Item ID: D407-667-105

Item Name: Fwd Crosstube - High 407

Draw Nbr	Revision Nbr
D407-667-145	Rev C (DEO)
DSI9565	A
DSI9628	A

DRAWING NO. D407-667-145	TITLE CROSSTUBE ASS'Y (407 HIGH FWD)	REV. C	DART AEROSPACE LTD ENGINEERING ORDER		D.E.O. NO. D407-667-145-C-1	SHEET NO. SHEET 1 OF 1	SCALE NTS
DRAWN 97	CHECKED AS	MFG. APPR. 18	APPROVED WD		DE APPR. H		
DATE 11.07.15	DATE 11.07.22	DATE 11.07.22	DATE 11/07/22		DATE 11.07.21

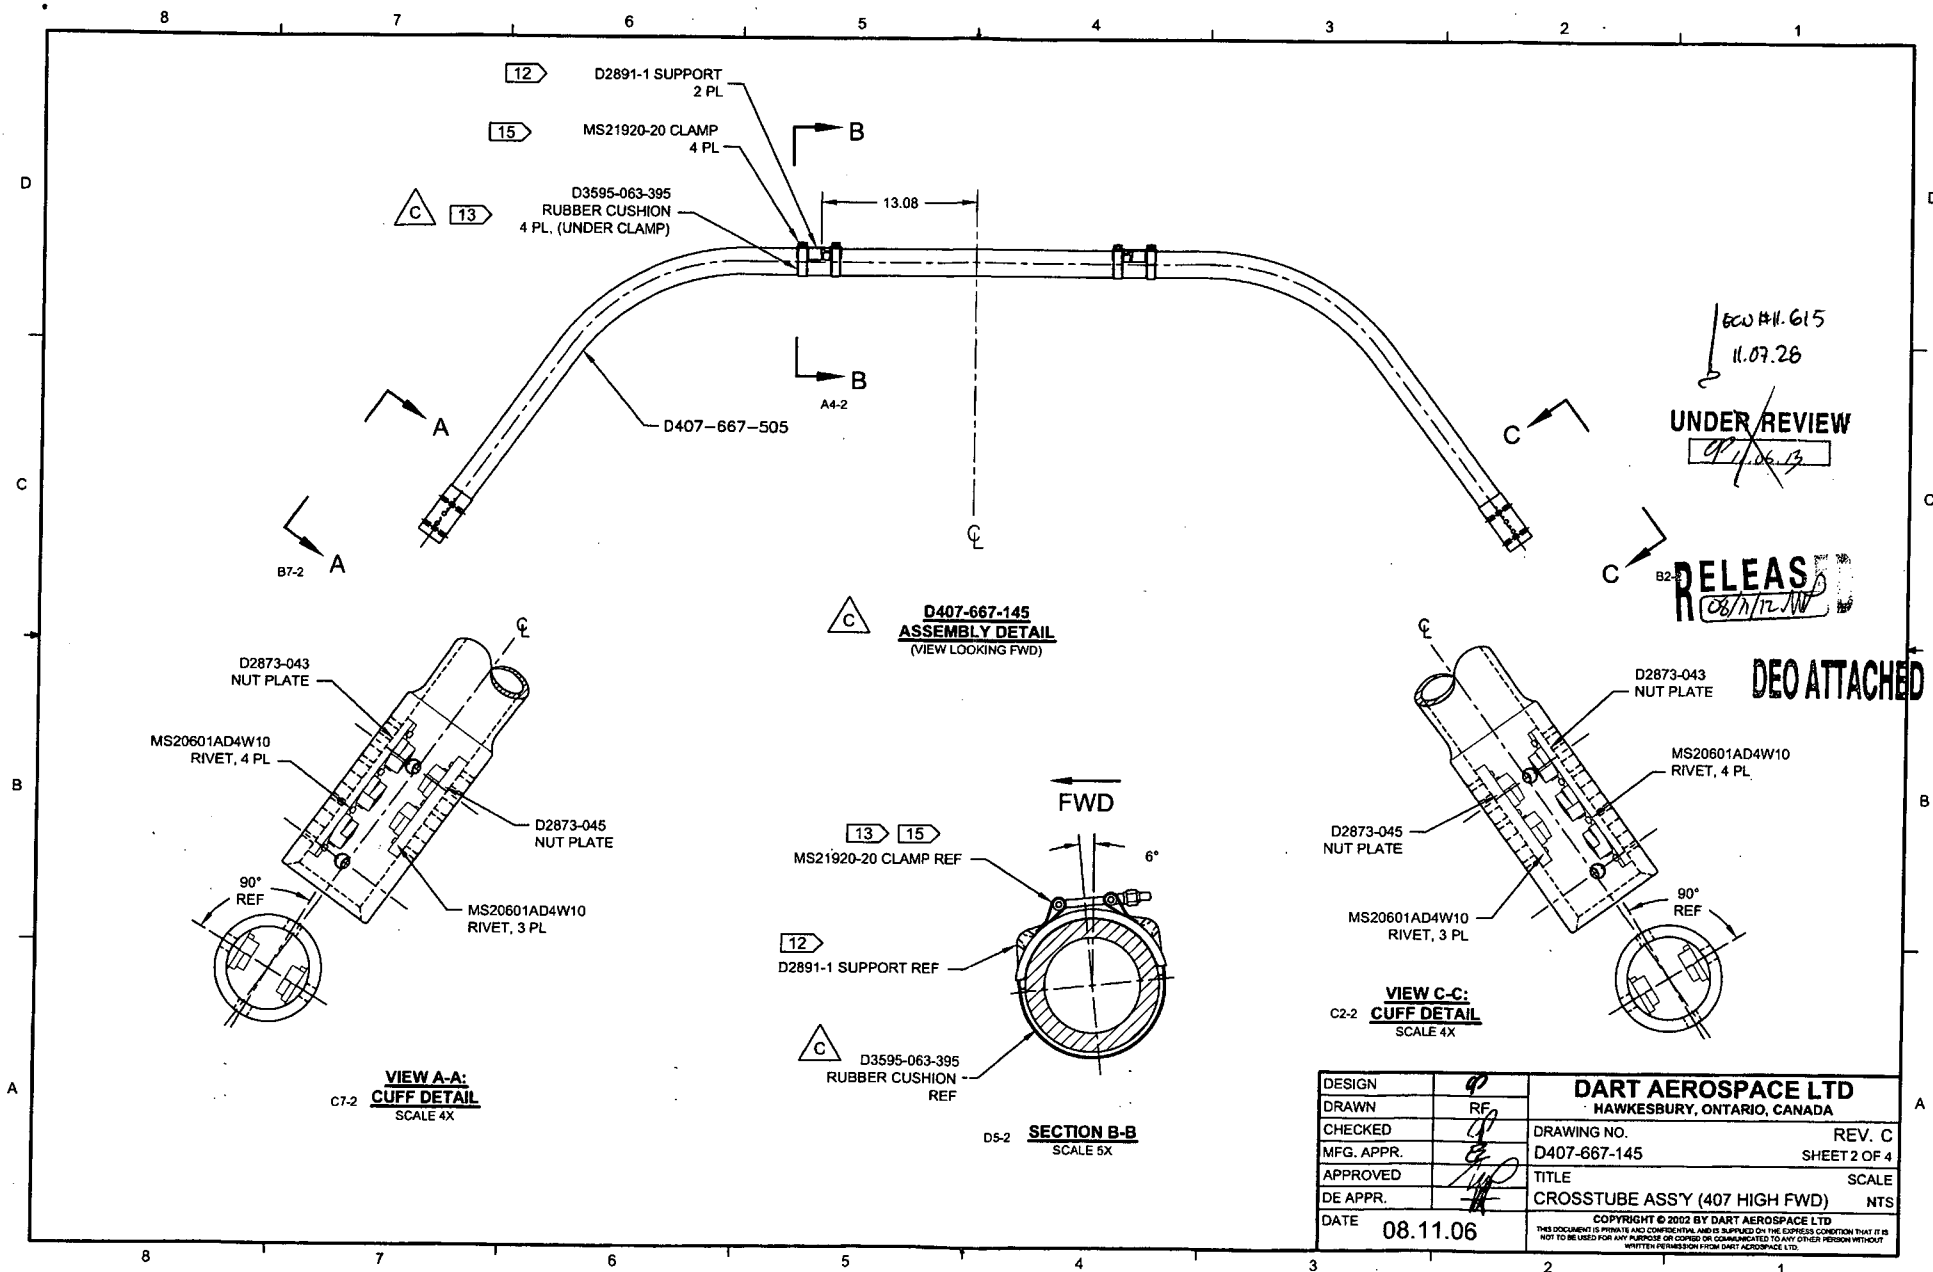
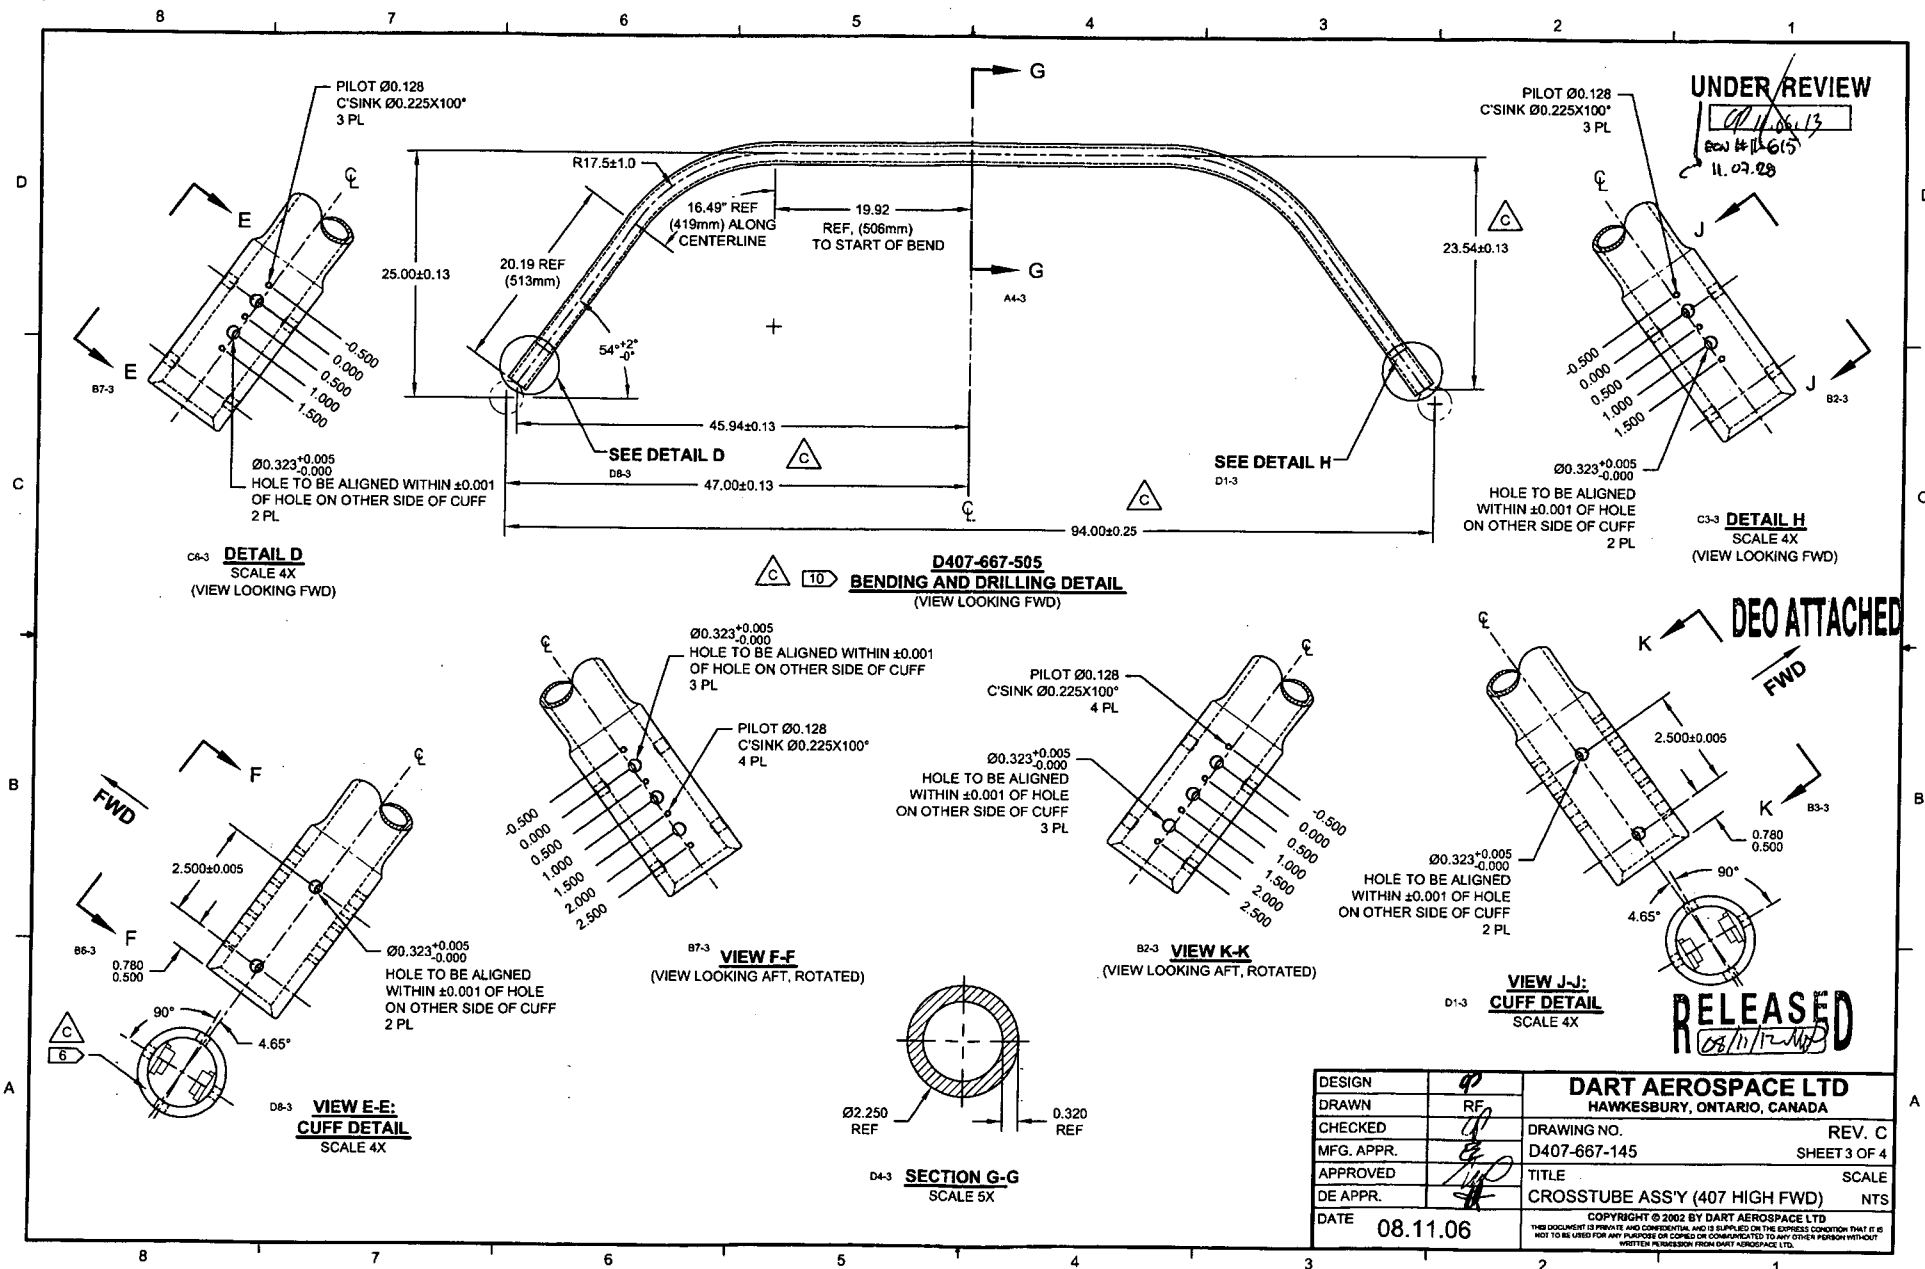
REPLACE MAGNOBOND WITH PROSEAL.

NOTE 12 & 15, SHEET 1 IS AMENDED AS FOLLOWS:

- 12) TO INSTALL D2891-1 SUPPORT: ABRASE MATING SURFACE OF SUPPORT AND CROSSTUBE WITH 180-GRIT SANDPAPER AND REMOVE RESIDUE WITH MEK (OR EQUIVALENT). APPLY A 0.04" TO 0.07" THICK LAYER OF PROSEAL 890 CLASS B-2 (OR AMS-S-8802 CLASS B-2) SEALANT TO MATING SURFACE OF SUPPORT.
- 15) TORQUE CLAMPS 80 TO 100 IN-LB. ENSURE AT LEAST 1.5 THREADS SHOWING IN SAFETY AND THAT NUT HAS NOT BOTTOMED-OUT AFTER TORQUING. **PRIOR TO PACKAGING, RE-CHECK TORQUE ON CLAMPS AFTER PROSEAL 890 SEALANT HAS CURED FOR 72 HOURS.**

DETAIL P
BONDING STRAP INSTALLATION 2 PL

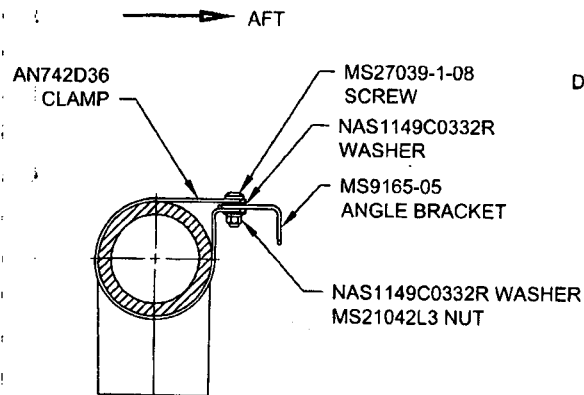
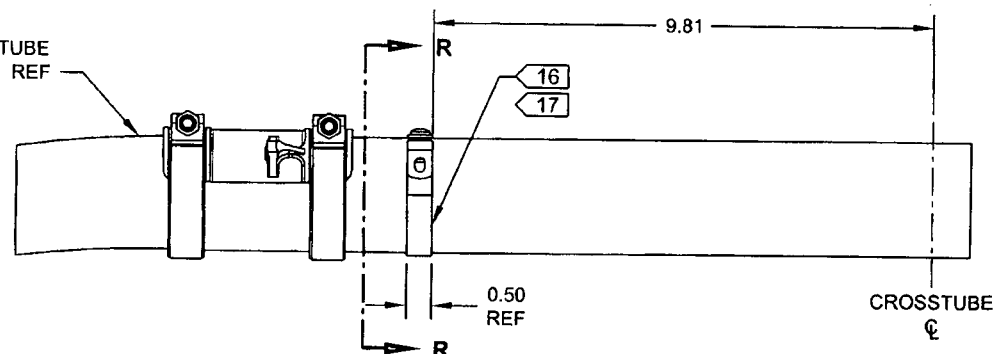
ADD ELECTRICAL GROUNDING STRAP

ADD

ITEM	QTY -145	PART NUMBER	DESCRIPTION
1	X	D407-667-145	CROSSTUBE ASSEMBLY (407 HIGH FWD)
10	2	AN742D36	CLAMP
11	2	MS9165-05	ANGLE BRACKET
12	2	MS21042L3	NUT (OR MS21042-3)
13	2	MS27039-1-08	SCREW
14	4	NAS1149C0332R	WASHER (OR AN960C10L)
